MEMORANDUM

TO: District of Columbia Board of Zoning Adjustment
FROM: Karen Thomas, Case Manager
JL Joel Lawson, Associate Director Development Review
DATE: June 12, 2019

SUBJECT: BZA Case 20047 – 3301 Lowell St NW (DGS Eaton Elementary) - **Special Exception** relief to permit renovation of Eaton Elementary school, including a new three-story multipurpose building and relocation of retaining walls on the campus.

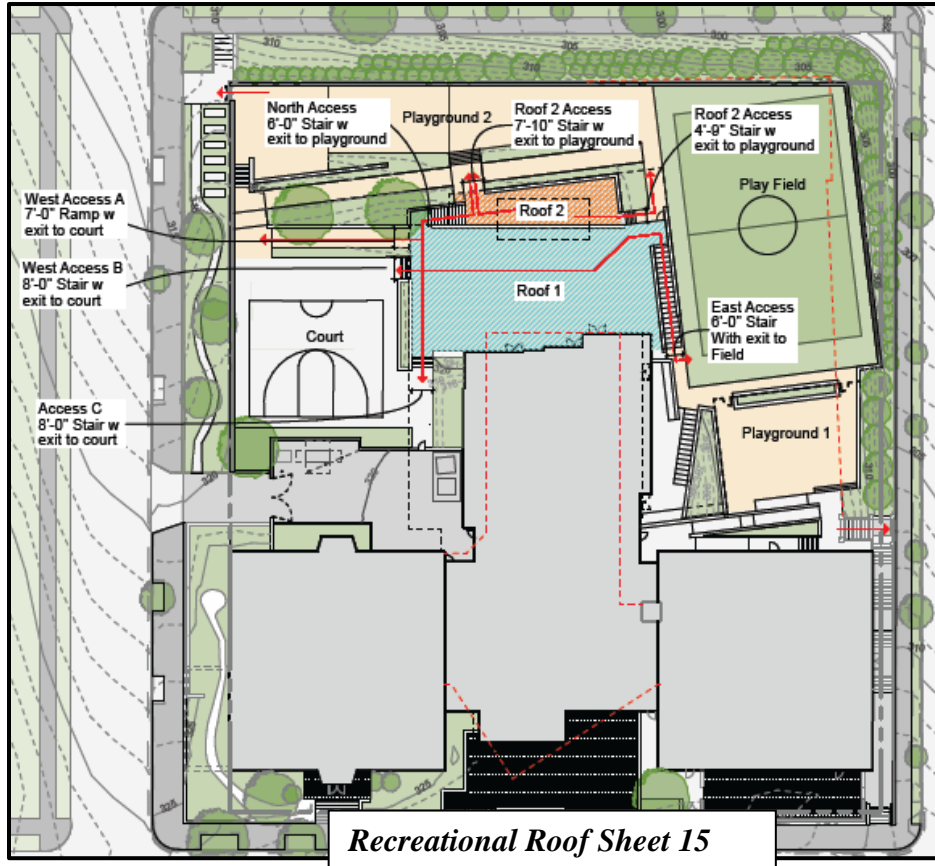
The property currently has several retaining walls of varying heights around the site's perimeter, as well as the interior as shown on Sheet 10 of Exhibit 30A1. These walls have continuously supported the variable topography, including at the highest elevation at 33rd Place and Macomb Street. The intent of the modernization project in part is to provide adequate and level play areas, while replacing some of the retaining walls in kind, or recladding them to present consistency in materials for the walls (Exhibit 30A1 Sheets 10-14). New and replacement walls would be an improvement over the existing and would continue to provide support for the site's grades. Full compliance in this instance would be unduly restrictive or unreasonable due to the site's topography and would unduly limit necessary outdoor play area.

The intent of the regulations is to control the location of bulk of retaining walls in relation to adjacent lots within the low density residential districts. Thus, the proposal is in harmony with the Regulations, as the walls are located within the site and well removed from residential property.

The retaining walls would be landscaped where appropriate, as currently exists to minimize its appearance and height as viewed from residential homes across the street. The use of neighboring property should not be adversely affected.

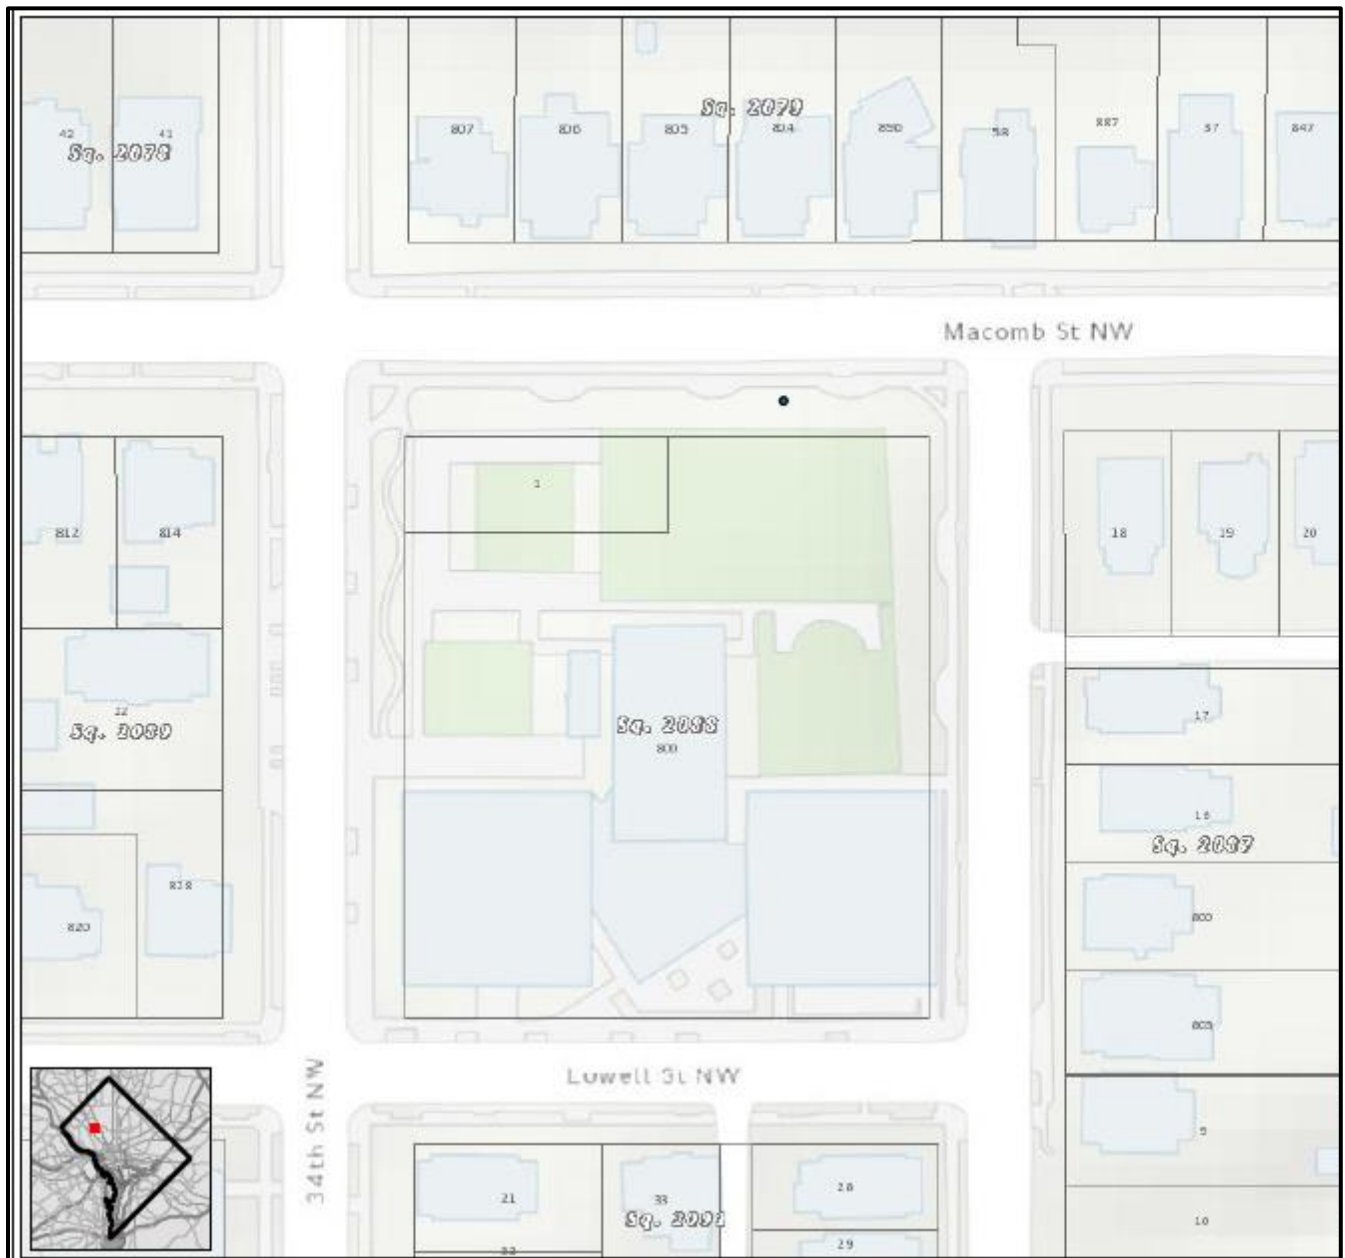
As shown in Exhibit 30A1 -Sheet 15, two new recreation areas would be provided in areas identified as Roof 1, above the gymnasium and Roof 2, above the stage. There would be up to seven access points from to areas around the play areas, including access ramps and stairs at 8 feet, maximum and 4 feet minimum in width. The subject required access areas for relief would be 8 feet, 7 feet and 6 feet wide. These all exceed the egress widths for the roof's occupancy under DC Building code requirements.

The proposal is in harmony with the intent of the Zoning Regulations as adequate access relative to the design capacity of play areas would be provided according to DC Code regulations.

The use of neighboring property would not be adversely affected by the width of access stairs. The stairs would be located entirely within the school's property and would provide ingress and egress to improved public space pedestrian access amenities to 34th Street.
